# Access Compliance Report

## Public Rights-of-Way

### (Curb Ramps)

Intersection ID: 14720	Main Street: E_5TH_ST	Cross Street: N_DOTGER_AV	Location: E
ADA ID: FF38C5B80DCA	Ramp Type: BlendTrans1	Initial Pass/Fail: Fail	Overall Compliance: No
Severity Score: 1.25			
Codes/Mitigation Info/Possible Solution		Field Measurements/Component Compliance

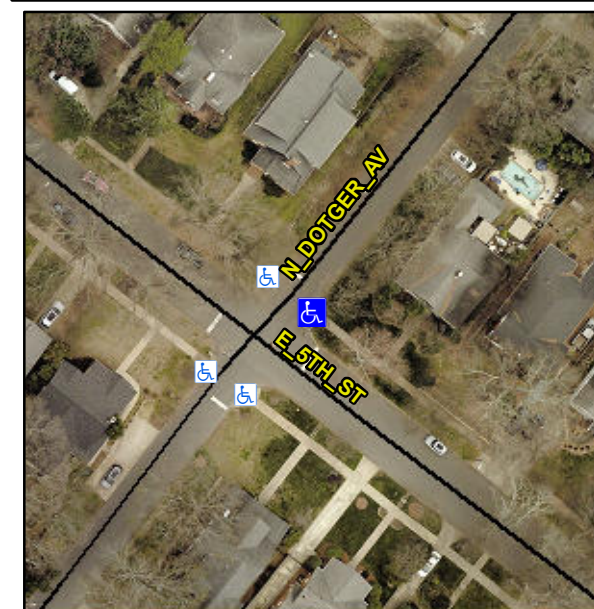
Compliance	Description	Data	Compliance	Description	Data
N/A	Ramp Length (in)	77.0	Yes	BlendTrans Slope (%)	2.2
Yes	Ramp Width (in)	48.0	No	BlendTrans XSlope (%)	3.4
N/A	Flare Type LT	N/A	N/A	Flare Type RT	N/A
N/A	Flare Slope LT (%)	N/A	N/A	Flare Slope RT (%)	N/A
N/A	Flare Traversable LT?	N/A	N/A	Flare Traversable RT?	N/A
N/A	Landing Length (in)	N/A	N/A	DWS Provided?	N/A
N/A	Landing Width (in)	N/A	N/A	DWS Contrast?	N/A
N/A	Landing Slope (%)	N/A	N/A	DWS Length (in)	N/A
N/A	Landing X Slope (%)	N/A	N/A	DWS Full Width?	N/A
N/A	Landing Curb? (Y/N)	N/A	N/A	DWS Offset (in)	N/A
N/A	Shared Landing?	N/A			
N/A	Gutter Ponding?	N/A	N/A	Gutter Slope (%)	N/A
N/A	Gutter Lip Ht (in)	N/A	N/A	Gutter X Slope (%)	N/A
N/A	Painted X Walk1?	No	N/A	Painted X Walk2?	N/A
	X Walk 1 Direction	To NW		X Walk 2 Direction	N/A
	X Walk 1 Width (in)	N/A		X Walk 2 Width (in)	N/A
	X Walk 1 Slope (%)	8.2		X Walk 2 Slope (%)	N/A
	X Walk 1 X Slope (%)	3.7		X Walk 2 X Slope (%)	N/A

N/A	Ramp inside XWalk1?	N/A	N/A	Ramp inside XWalk2?	N/A
	Road Slope (%)	3.7		Clear Space?	N/A
	Road X Slope (%)	8.2	N/A	Clear Space to XWalk (in)	N/A
N/A	Any Obstructions?	N/A	N/A	Storm Grate/Utility Hazard?	N/A
	Obstruction Type			Storm Grate/Utility Type	
		N/A			N/A
			Yes	Surface Condition? (G/P)	Good
			N/A	Curb Slope (%)	5.0

**Remove & Replace Curb Ramp With Two New Directional Ramps or Equivalent.**

**R304.5.3**
